**TOWN OF BAY HARBOR ISLANDS
MORRIS N. BROAD COMMUNITY CENTER
1175 95TH STREET
BAY HARBOR ISLANDS, FL 33154**

DEVELOPMENT & REVIEW COMMITTEE MEETING

RESPONSE LETTER TO COMMENTS ROUND #1

PROJECT: BAY HARBOR LUXURY TOWNHOMES

FLOOR
PLAN PER
UNIT

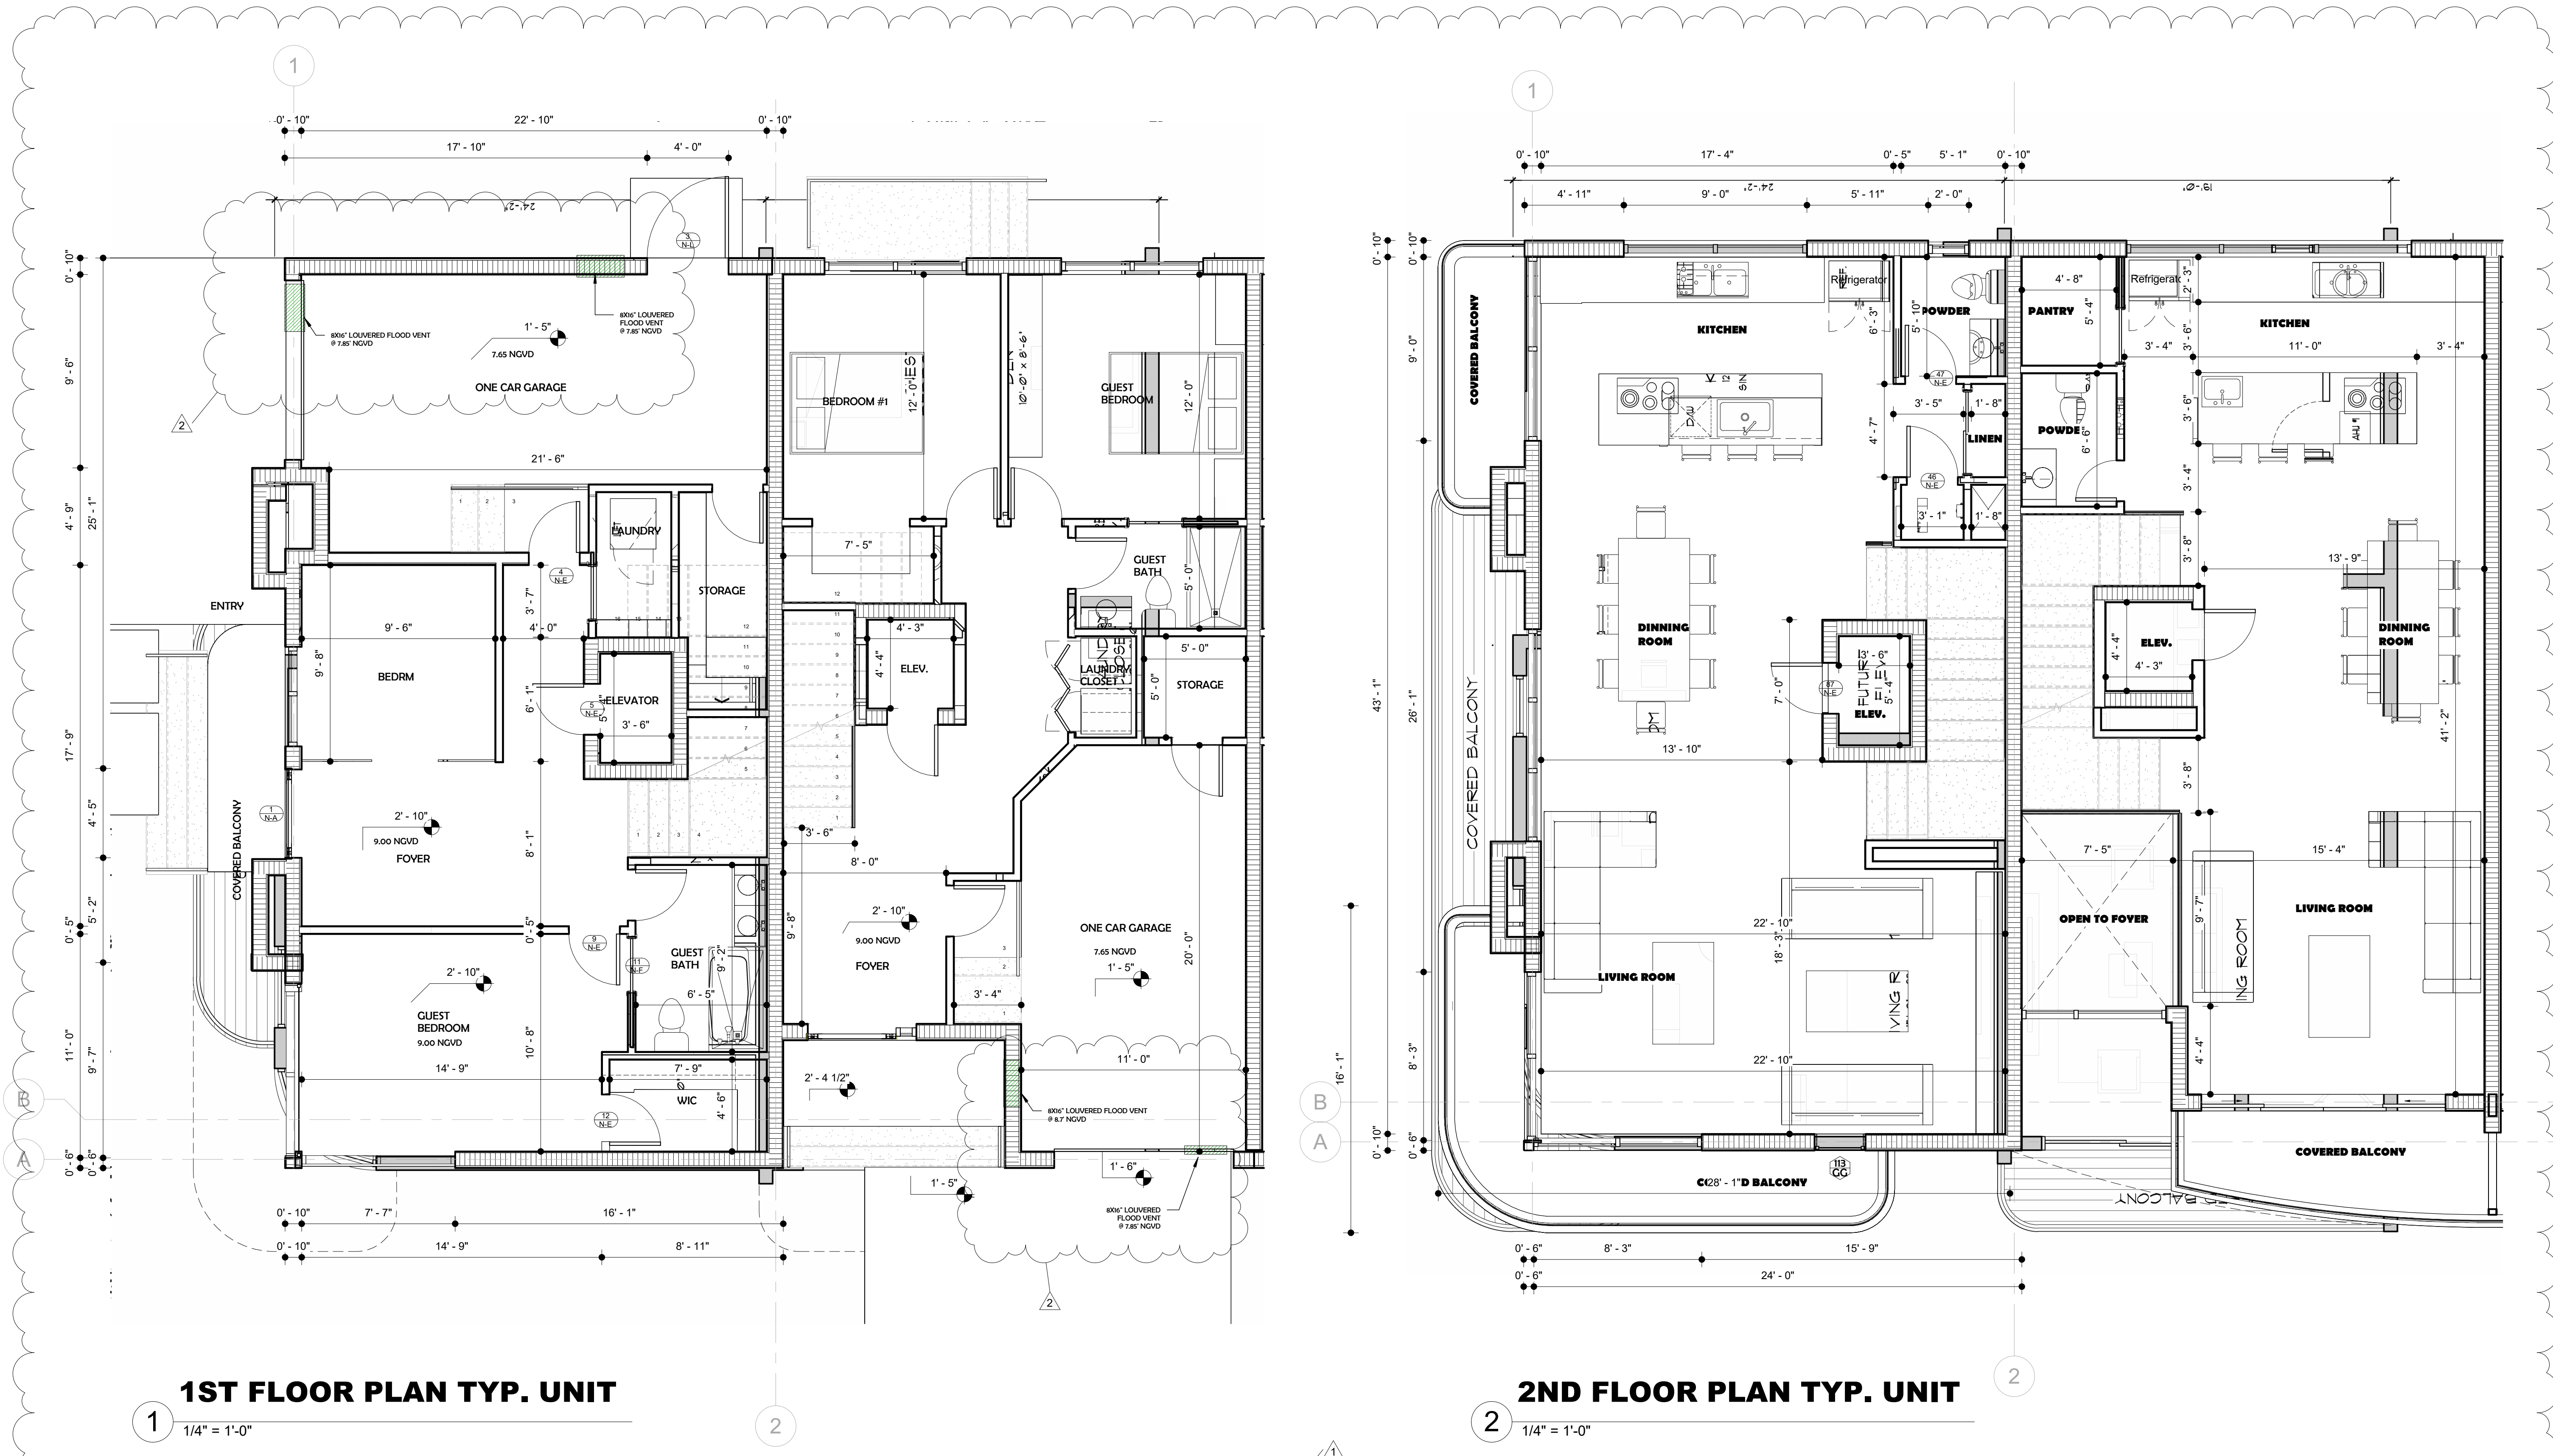
9. PER SEC. 23-9 EACH UNIT MUST PROVIDE A SEPARATE STORAGE AREA OUTSIDE OF THE D.U. PROVIDE DIMENSIONS /SF. FOR THE STORAGE. (MIN 25 SF)

R/ STORAGE AREAS PROVIDED AT EACH DWELLING, COMPLYING WITH REQUIREMENTS OS AREA AND HEIGHT. SEE FLOOR PLAN SHEETS A-101, A-107

WATER & SEWER CONNECTION PLAN

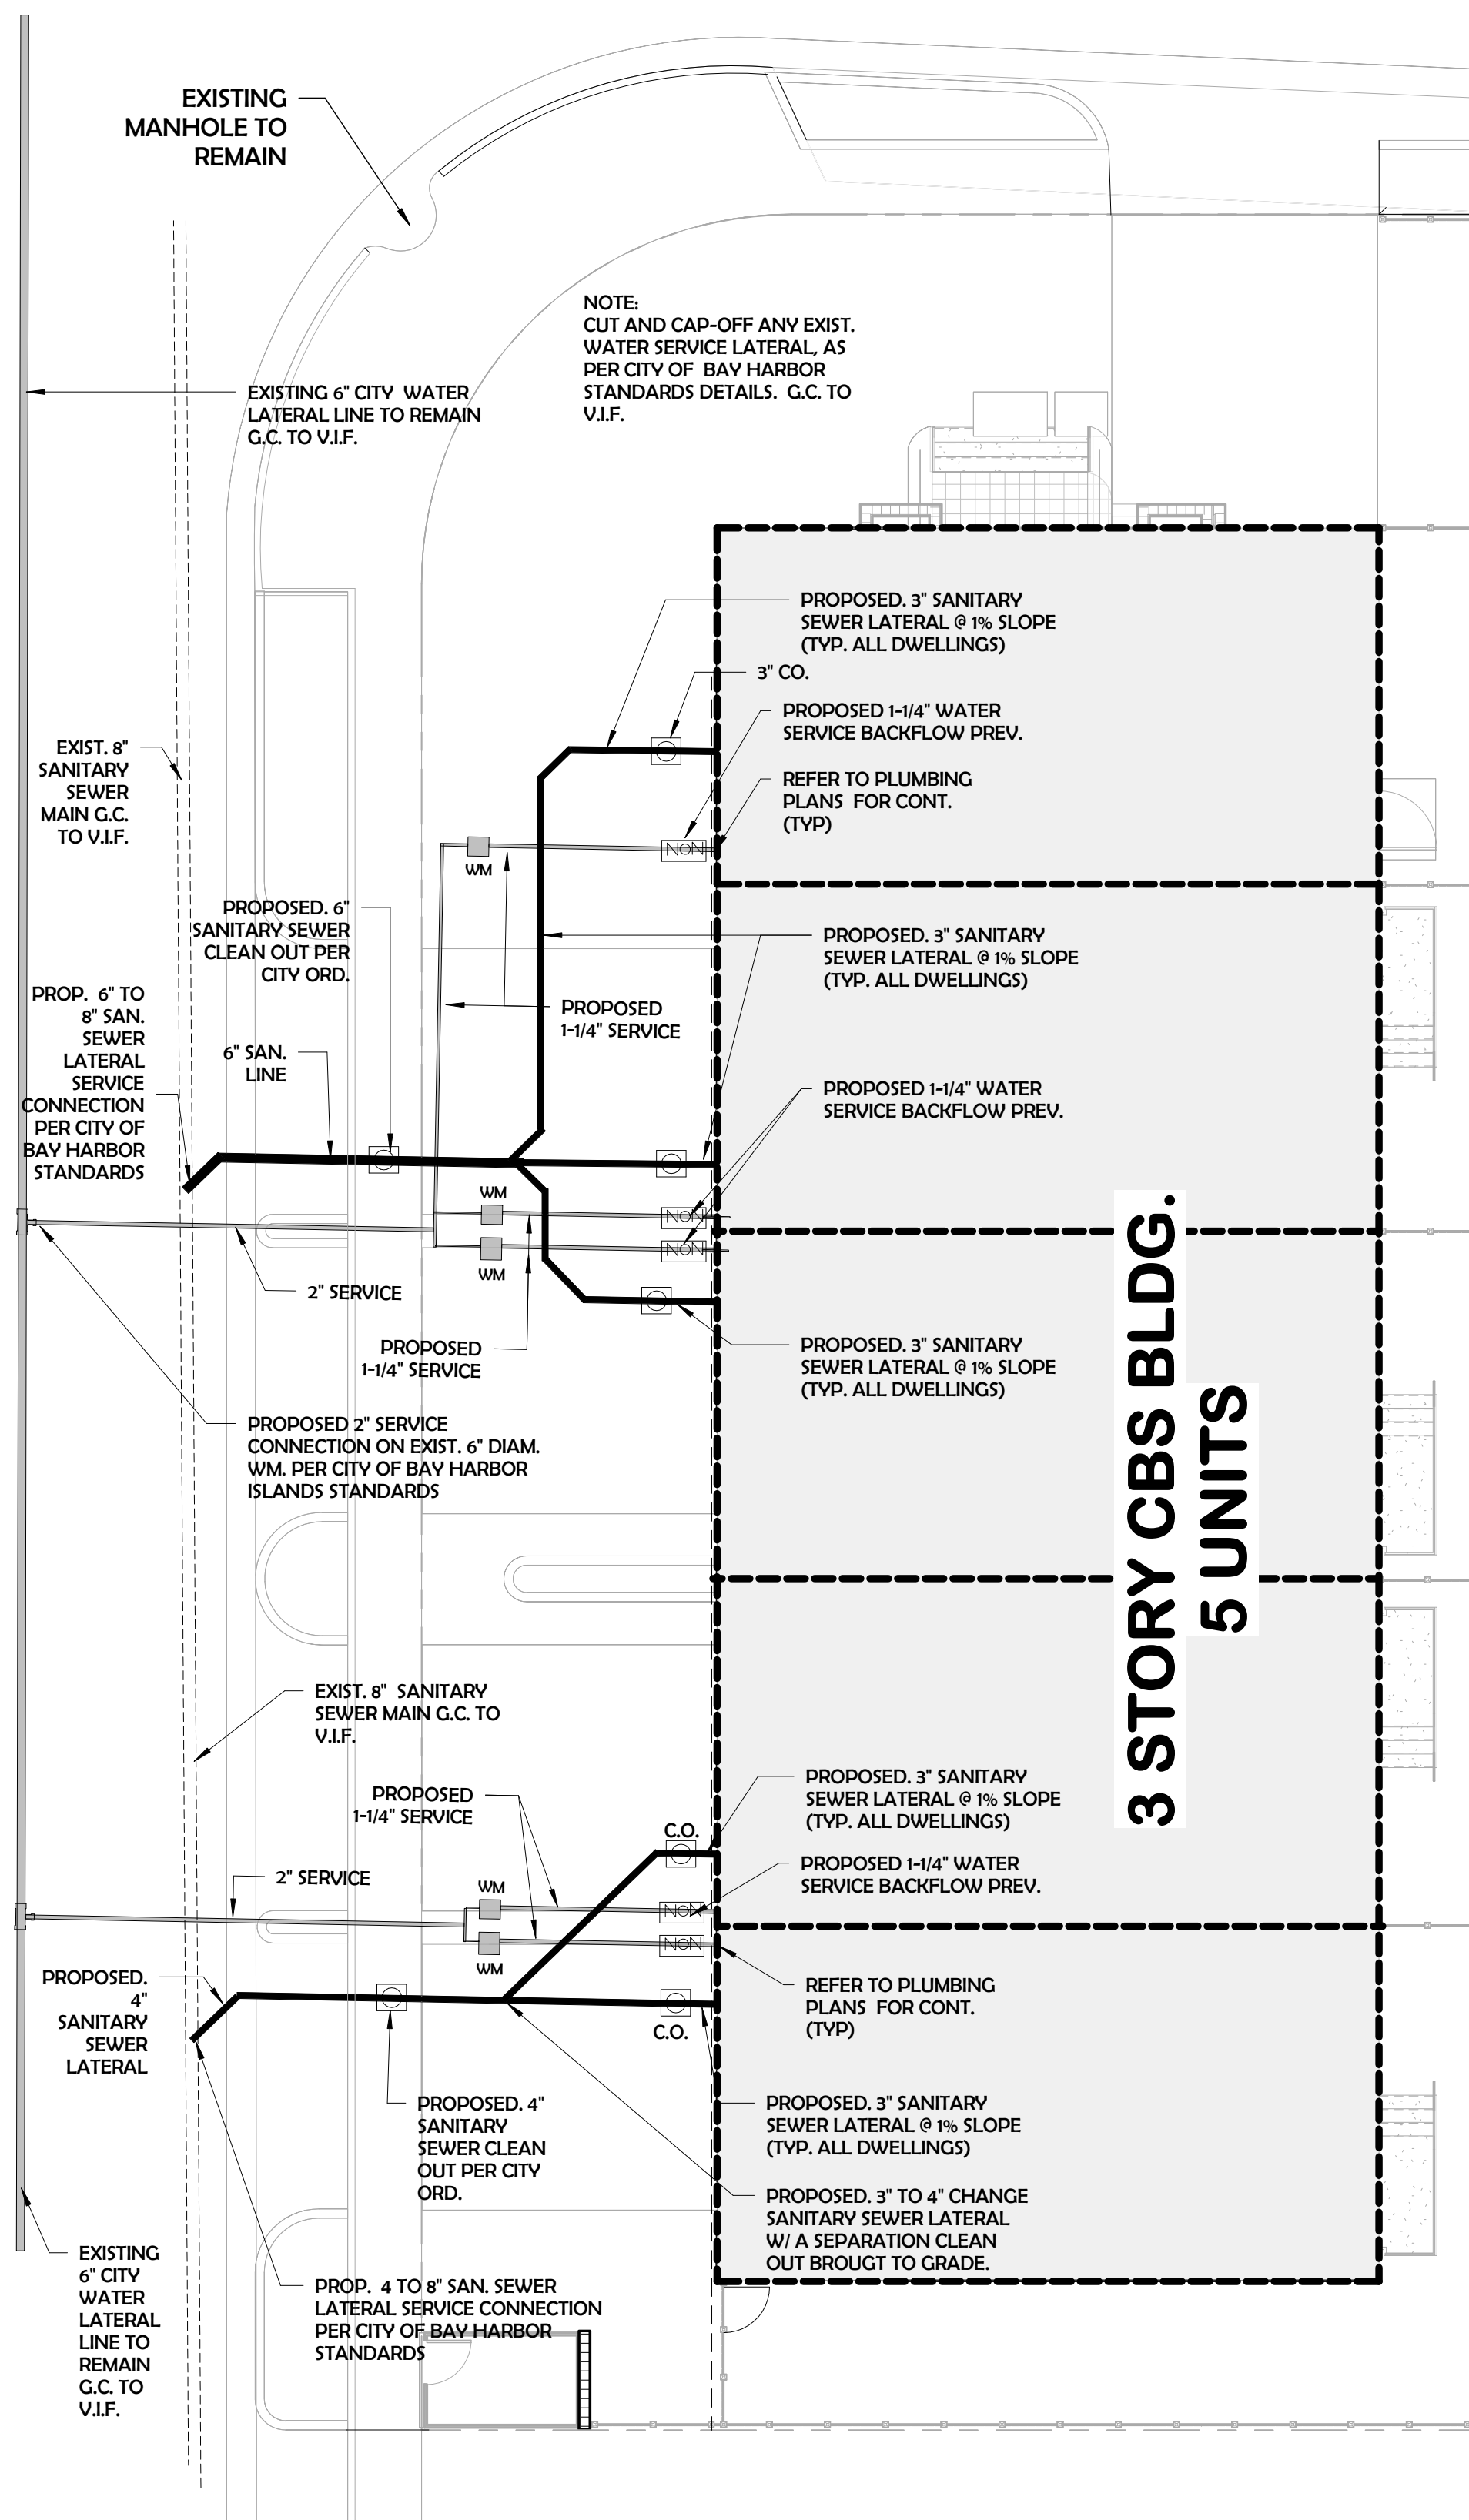
1. NO CIVIL DRAWINGS PROVIDED WITH THE SET OF DRAWINGS
R/ NEW CIVIL PLANS PROVIDED, SHEETS C-1, C-2, C-3, C-4, WS-1
